KPMB ARCHITECTS

# SUBCOMMITTEE MEETING NO. 3

# Revised Envelope Design

# Revised Sawtooth Façade Design

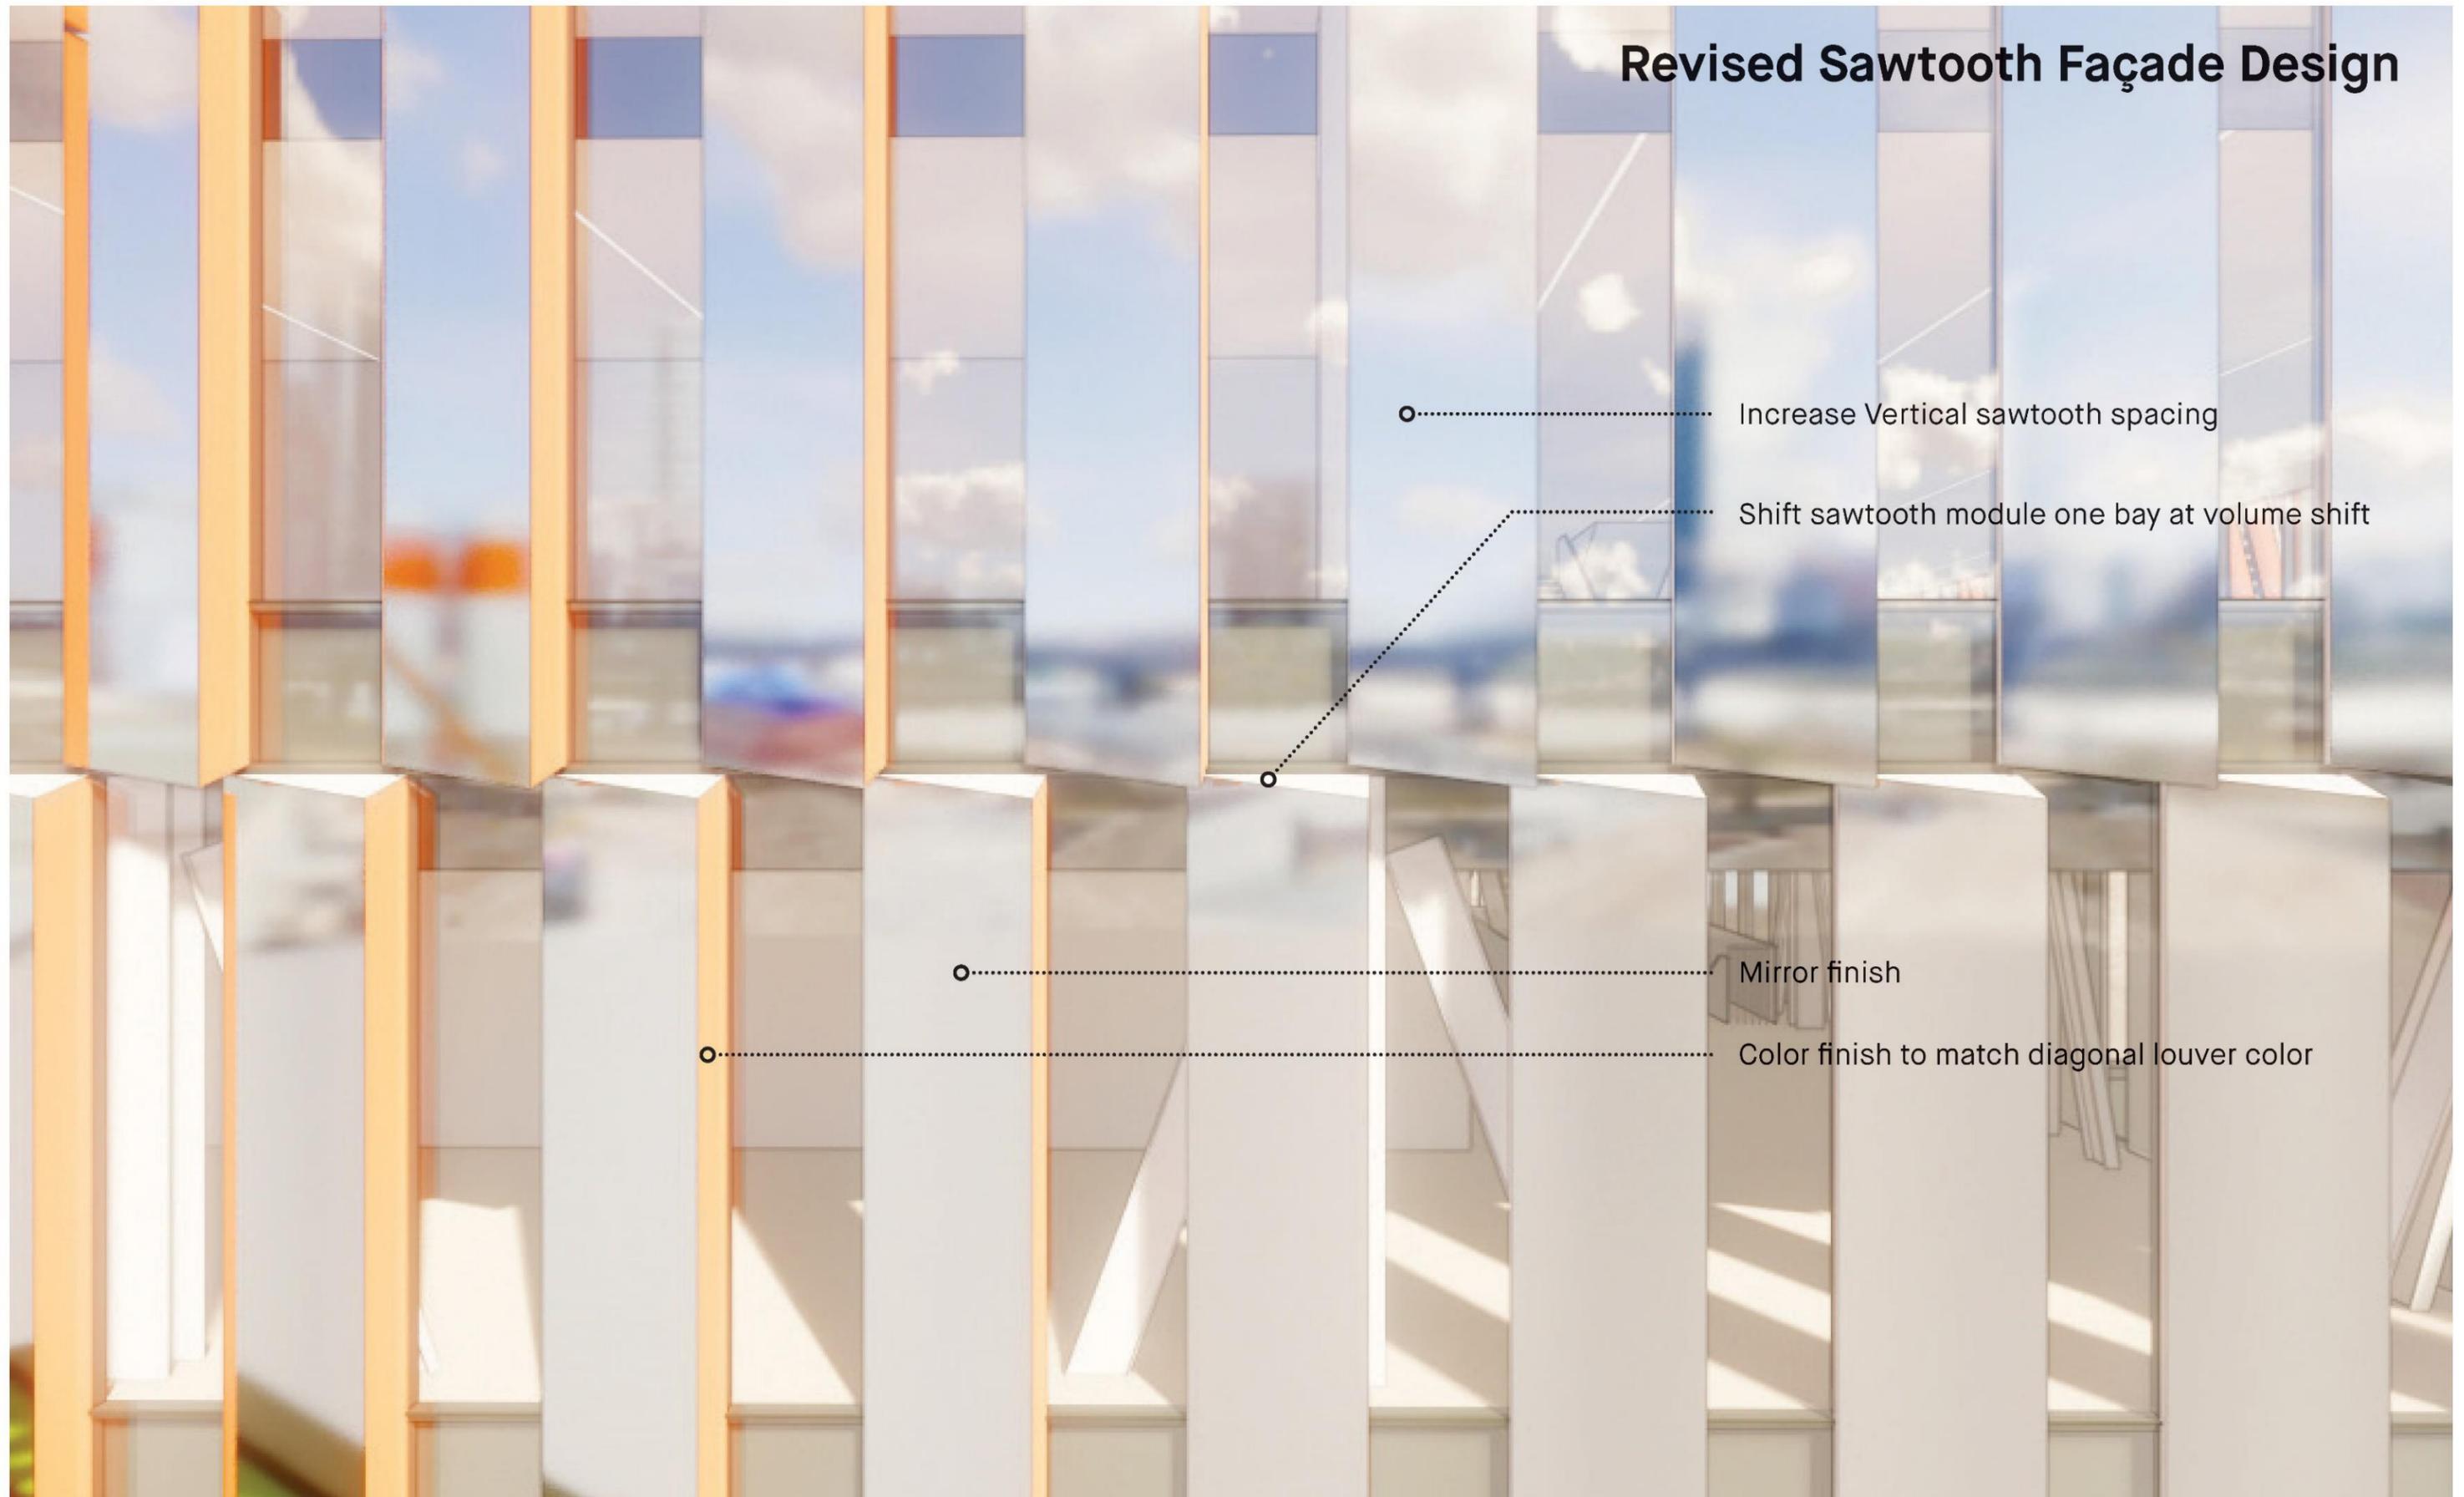
Increase Vertical sawtooth spacing

Shift sawtooth module one bay at volume shift

Mirror finish

Color finish to match diagonal louver color

# Revised Sawtooth Facade at Terrace Levels

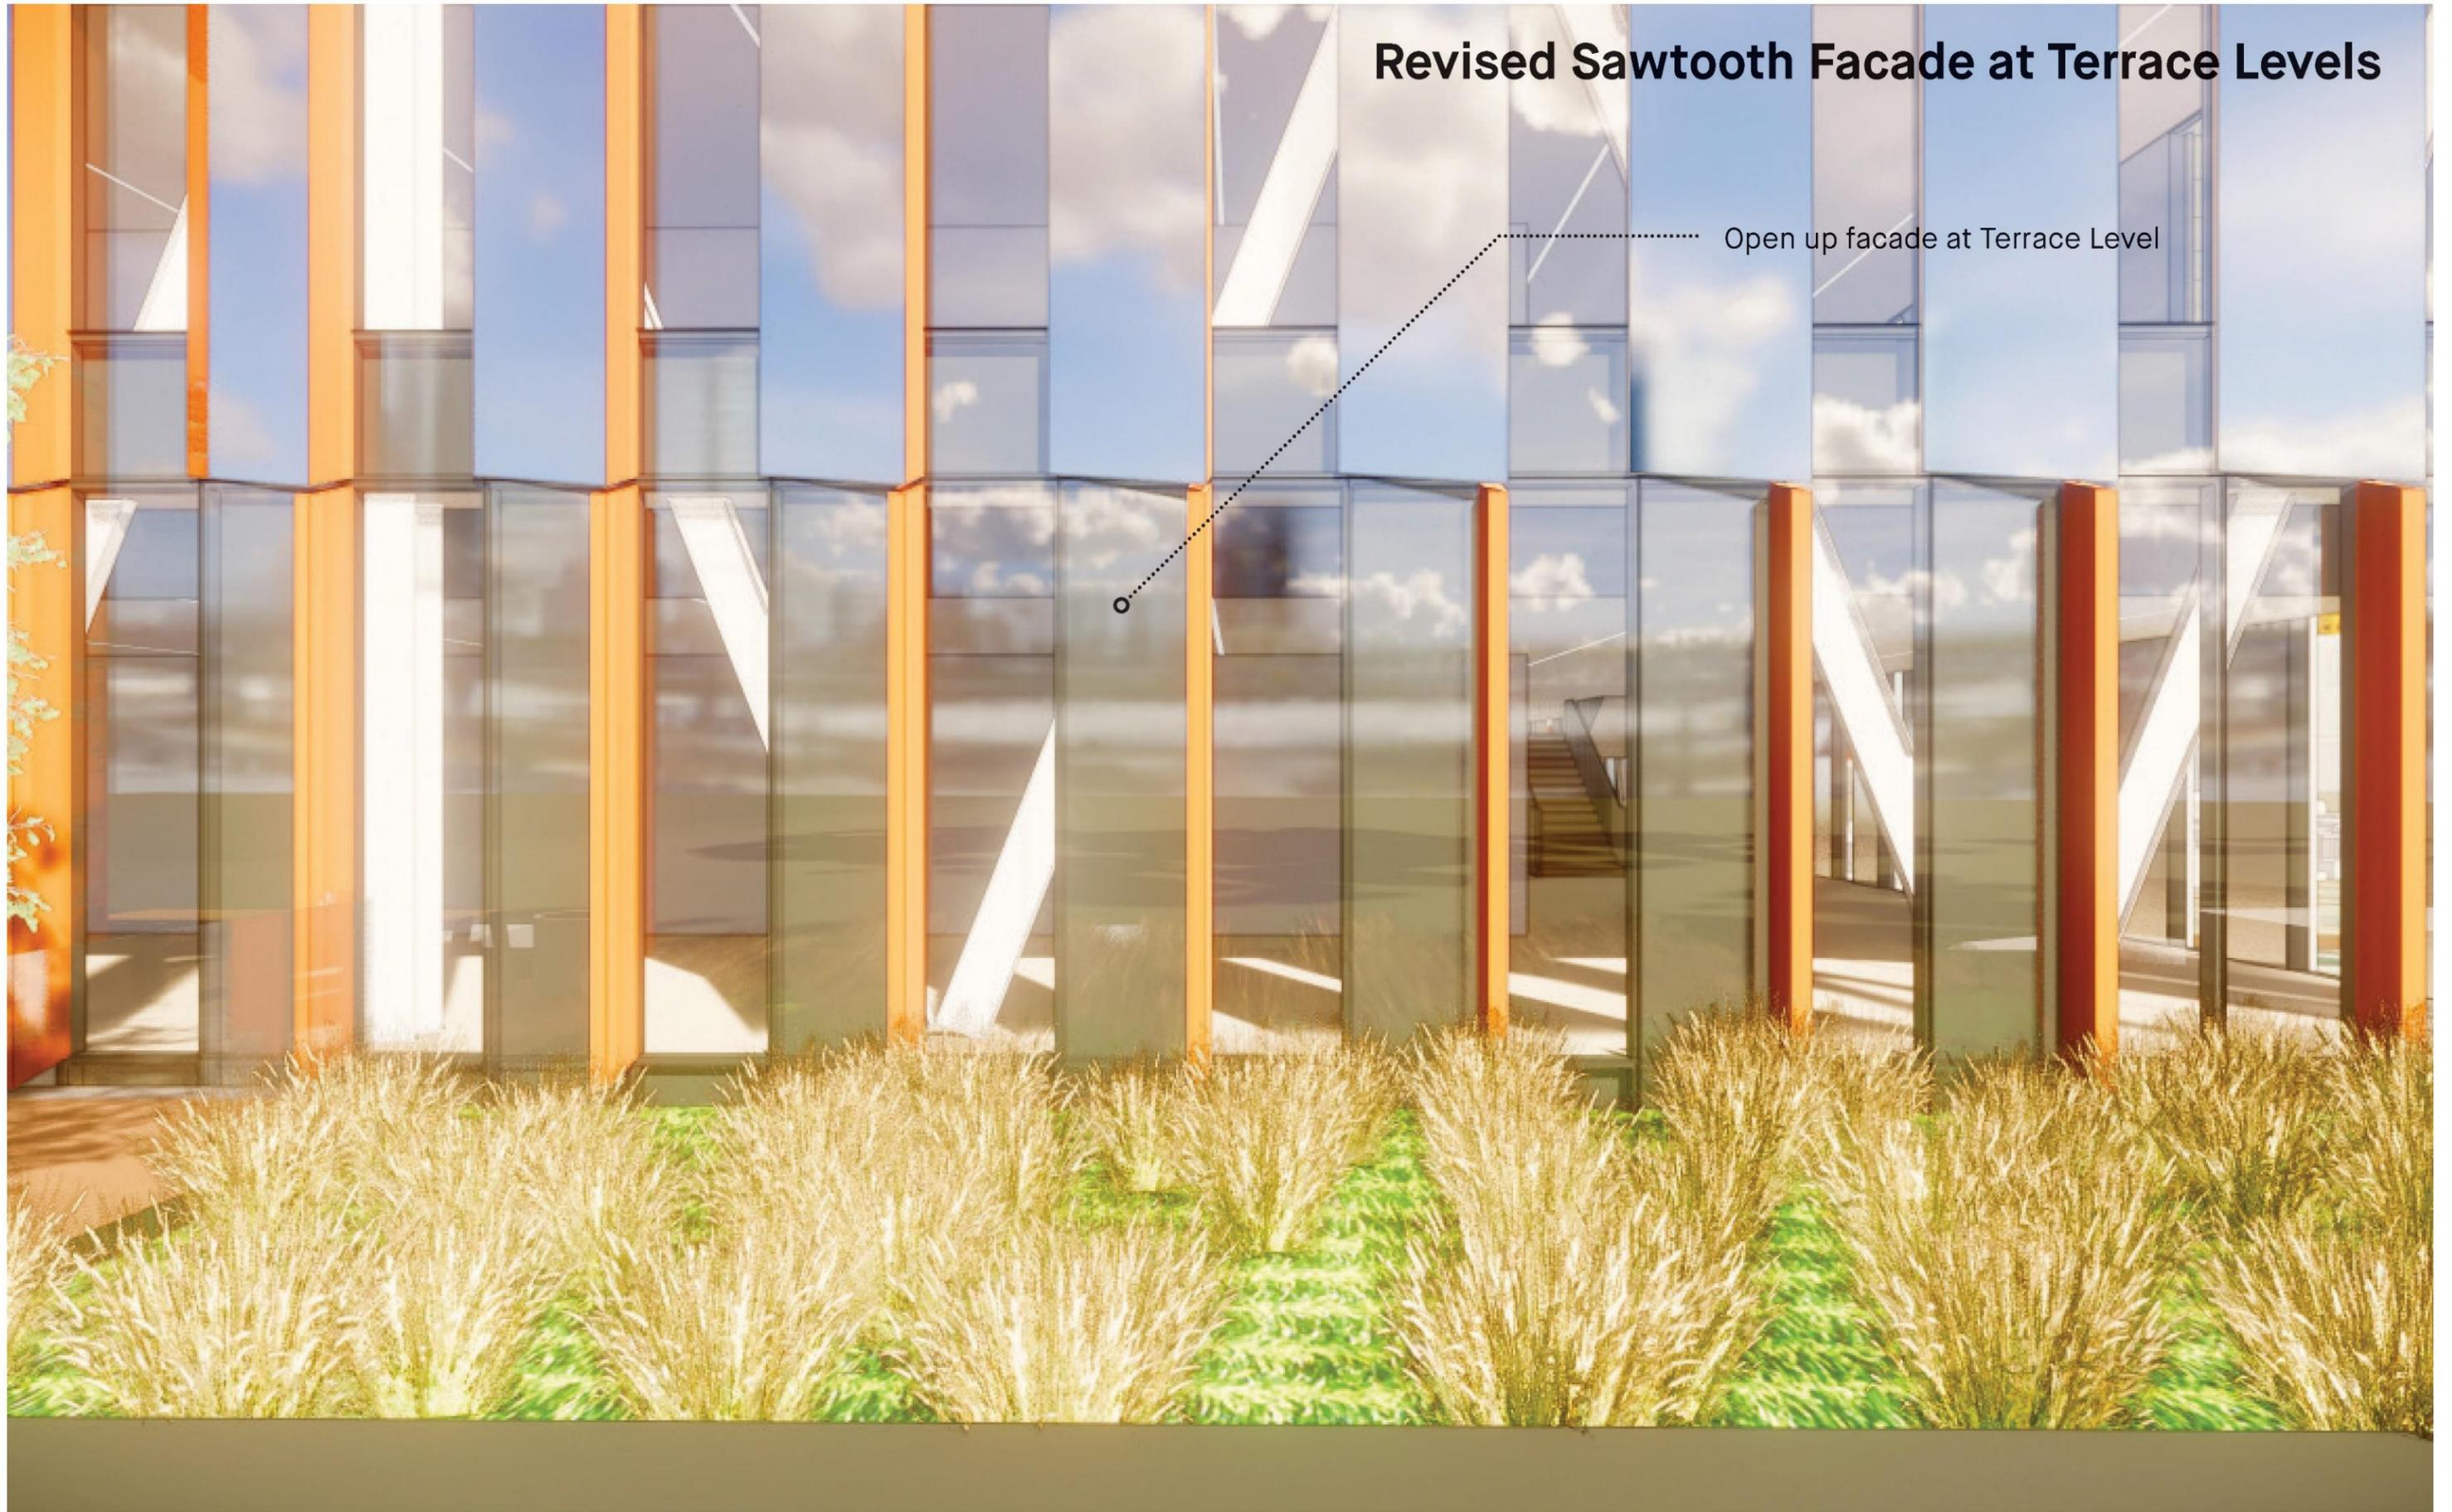
Open up facade at Terrace Level
